Date:	24 th May 2024	Application Number:	LU-2023-112105-00/SG-2023-112106-00/NC-2023-112107-00
Reporting Planner:	Sarah Exley	Site Visit on:	20th March 2024

Applicant:	NZHG Gisborne Limited
Property Address:	556 – 560 Aberdeen Road, Gisborne
Legal Description:	Lot 2 DP 1585 contained in Record of Title GS2B/162; Part Lot 1 DP 1585 contained in Record of Title GS110/25; Lot 1 DP 1817 contained in Record of Title GS2B/282
District Plan:	Te Papa Tipu Taunaki o Te Tairāwhiti – Tairāwhiti Resource Management Plan
Zoning:	General Residential
Other Restrictions:	Land Overlay 1; Rongowhakaata (Rongowhakaata Claims Settlement Act 2012); Te Aitanga-a-Māhaki Area of Interest; Reticulated Services Boundary; Aberdeen Road – Collector Road
Activity Status:	Discretionary

1.0 INTRODUCTION

Figure 1 Snip of proposed subdivision and land use scheme plan.

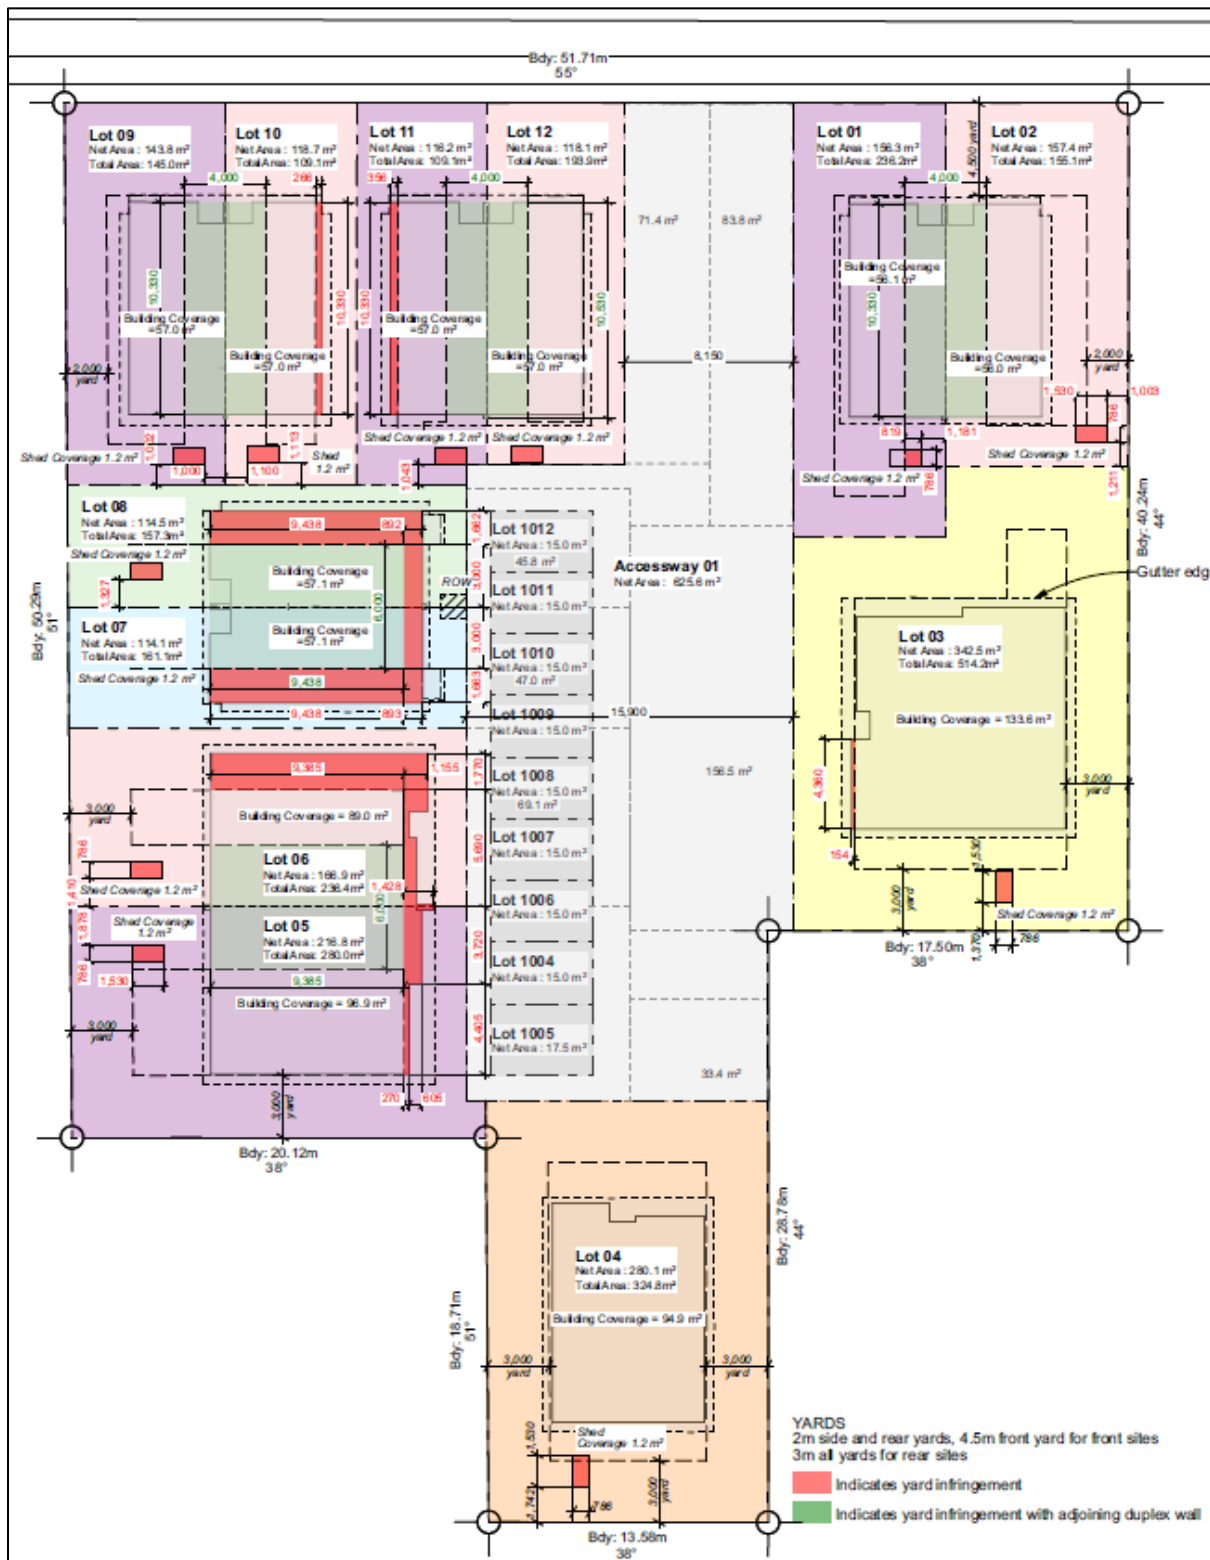
The layout of the proposed development has complied with the required recession planes and yard setbacks with external boundaries, thus achieving the permitted baseline for shading on adjacent properties. However, the layout is in breach of required yard setbacks and recession planes for internal boundaries.

Due to the duplex layout, Lots 1, 2 and 5 – 12 will infringe the relative height in relation to boundary recession plane along the common party wall boundary. Additionally, the proposed dwellings will infringe the recession planes to the internal boundaries as follows:

I consider these infringements create significant restriction on access to daylight and privacy for the proposed dwellings. The applicant has stated that “*onsite privacy will not be compromised as a result of the proposed lot sizes noting that living rooms do not overlook each other.*” I disagree with this as the breach yard setbacks and recession planes mean other rooms do overlook into other properties, especially from upper stories into other property windows and outdoor areas.

Figure 2. Snip of proposed recessed parking for five vehicles along Aberdeen Road.

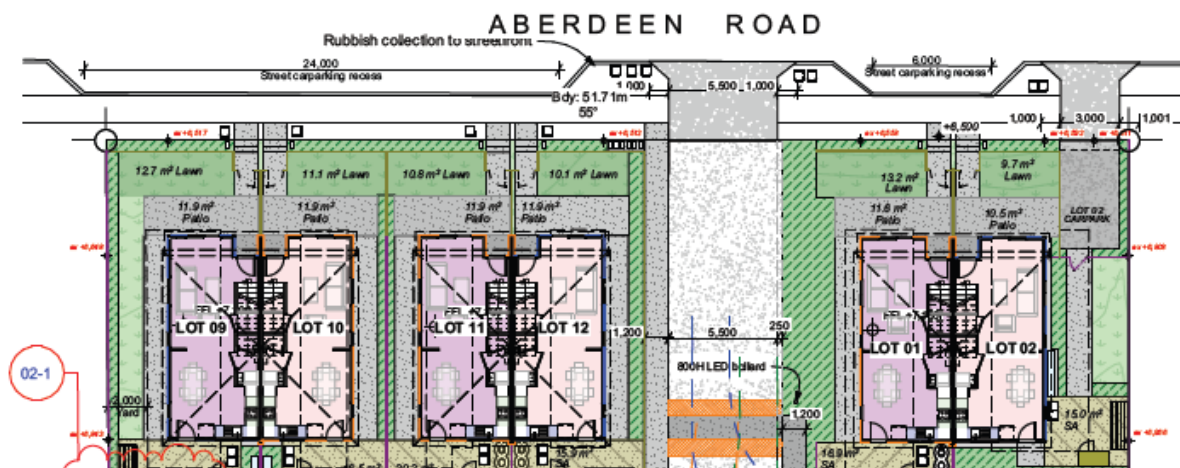
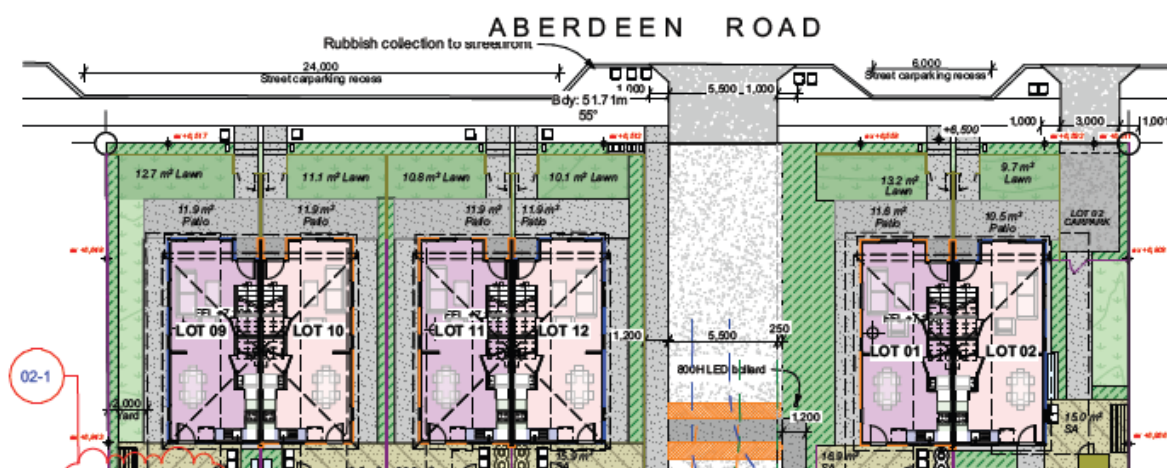
Throughout the consent process the Applicant submitted revised plans showing recessed parking on Aberdeen Road and to locate post boxes to the front of the site. There is an effect on further reducing landscaping amenity by removing the grass berm in the road reserve and replacing with an increased sealed surface. This visually adds to the lack of openness and hard-surface dominance of the development.

Throughout the consent process the Applicant submitted revised plans showing recessed parking on Aberdeen Road and to locate post boxes to the front of the site. This was suggested by Council's Development Engineer as a means to resolve the above issues. The recessed bay will allow 5 cars to park and space for kerb-side waste and recycling-collection without causing undue hazard to oncoming traffic in the live lane.

However it is not practical to rely on a mitigation measure occurring outside of the property boundaries. In addition, there is an adverse effect on further reducing landscaping amenity by removing the grass berm in the road reserve and replacing with an increased sealed surface.

Council's Development Engineer considers sight lines are improved for vehicles exiting the accessways and there is sufficient parking provided for the demand created. Council's Development Engineer also considers the demonstrated manoeuvring tracking curves are acceptable and vehicles will be able to exit the site in a forward-facing manner and that Aberdeen Road can accommodate the extra vehicle trips generated

While the Development Engineer considers the proposal has created a safe access for residents and other road users, I note there is the added effect of further reducing landscaping amenity. Again, a less-dense site would achieve both safe access for residents and other road users as well as better onsite amenity. At this stage, I consider the traffic access proposal will result in only minor effects on the environment.

Figure 3. Snip of proposed 24% site coverage landscaping.

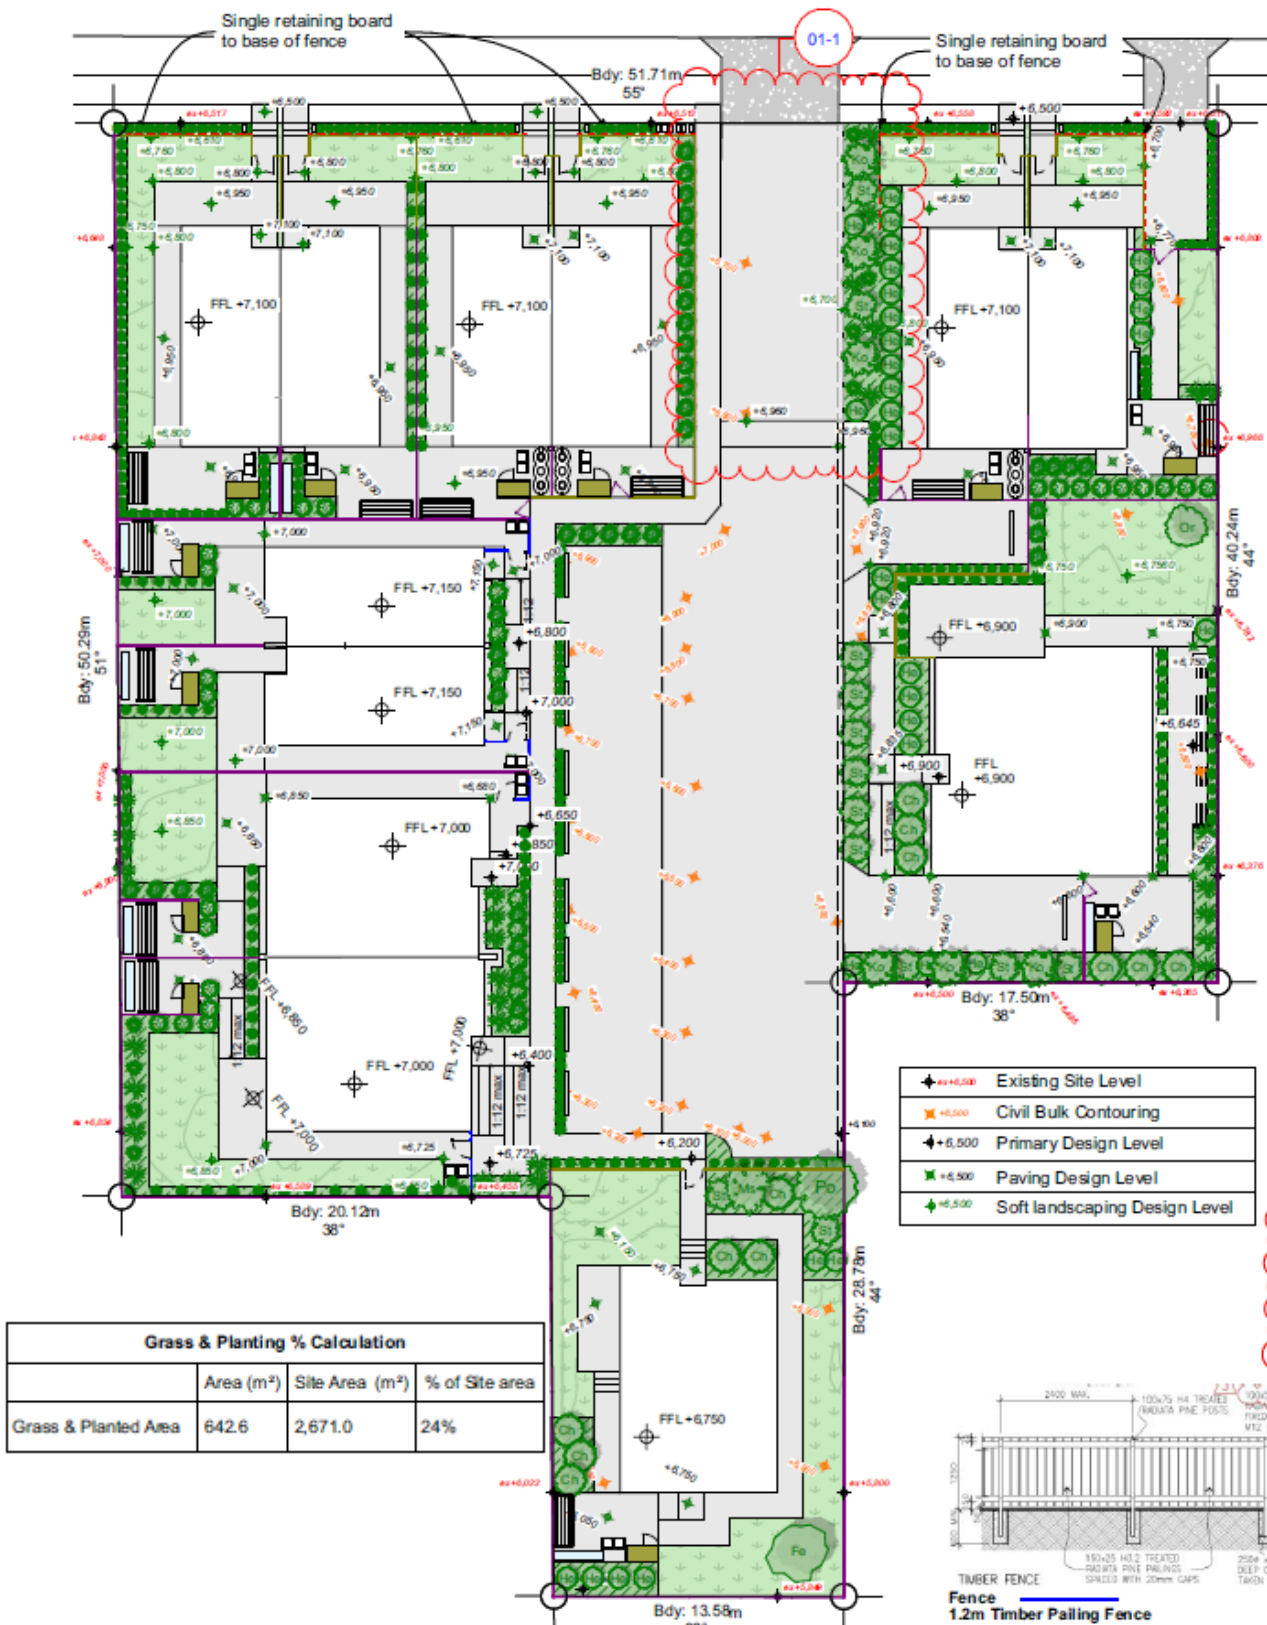
The applicant has submitted a landscaping plan showing 24% of the site will be planted in various species. This is 642m² of 'grass and planting' in area, compared to over 1,000m² (>37%) impervious surface area and 852m² (or 32%) total building coverage.

The majority of the proposed species are small shrubs or compact hedging. I do not consider the proposed landscaping to mitigate the effects of combined impervious surface area and dense building coverage.

I am unable to agree with the applicant's assessment. The intent of the landscaping is not to completely screen visibility of the buildings however, landscaping should provide a reasonable level of amenity against the bulk and density of the development, not just when viewed from sites external to the property. I do not believe that this can be achieved in a manner which offsets the scale of development nor will the landscaping achieve a similar level of amenity to the present landscaping experienced in the wider environment of Aberdeen Road and the General Residential zone.
